Project No.: 941-80-24-32
SENT VIA: EMAIL

**SUBJECT: Response to Comments from Appropriative Pool following 2025 Safe Yield
Reevaluation Calibration Workshop #2**

This letter documents our responses to the Appropriative Pool's comments following the August 6, 2024 workshop¹ regarding the calibration and uncertainty analysis of the 2025 Chino Valley Model (2025 CVM) as part of the ongoing 2025 Safe Yield Reevaluation. Thomas Harder and Company (TH&Co; Jim Van De Water, PG, CHG and Thomas Harder, PG, CHG) submitted the comments on behalf of the Appropriative Pool (AP) in a letter dated August 23, 2024.

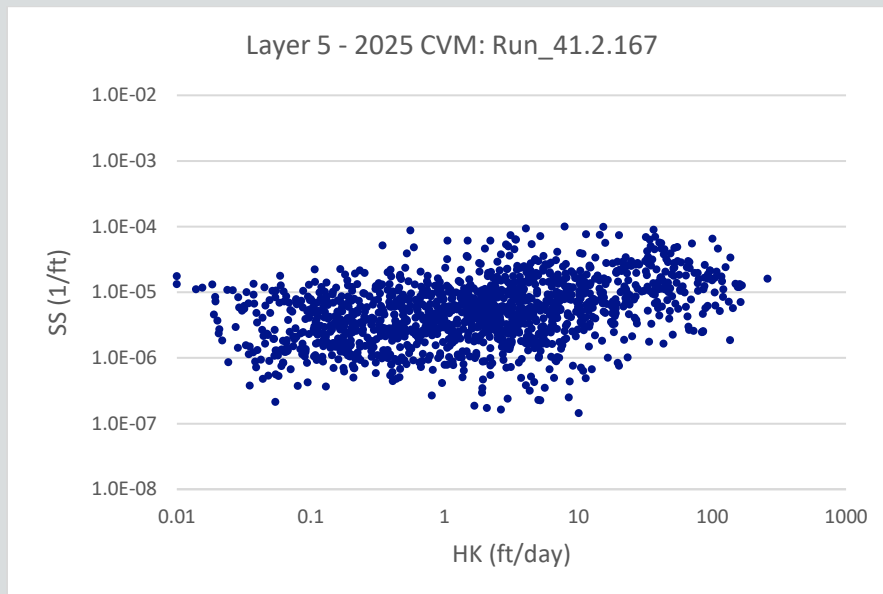
Has WY checked the parameter fields for internal consistency? That is, are areas of relatively high specific yield and high vertical conductivity reasonably co-located with areas of high lateral hydraulic conductivity (Kx)? Or, conversely, are areas of relatively low specific storage (Ss) reasonably co-located with areas of high lateral hydraulic conductivity (Kx and/or Ky)? The figure below shows a model with roughly 28,000 parameters assigned to Ss and another 28,000 parameters to Kx. WY may want to consider developing this type of figure as an internal check for inconsistent parameter associations. Inconsistent parameter associations could lead to the unrealistic parameter field shown on Slide 10.

The parameter field presented in slide 10 was shown to clarify our use of the term “overfitting” from the 5/29 workshop. Our current results do not suggest that parameter fields are overfit. We have developed figures as you suggested, such as the one below. We will include similar charts in the more detailed documentation of the calibration and uncertainty analysis.

This figure shows HK versus SS for model cells in Layer 5 for one of the realizations in the PESTPP-IES run with 25,326 parameters. HK and SS are slightly positively correlated. This observation is in line with studies^{2,3} that suggest no clear spatial correlation between K and S_s in heterogeneous aquifers. The relationship between K and S_s is complex and depends on various factors, such as the size and compressibility of the porous media. It's often necessary to consider both properties together to understand the behavior of groundwater systems.
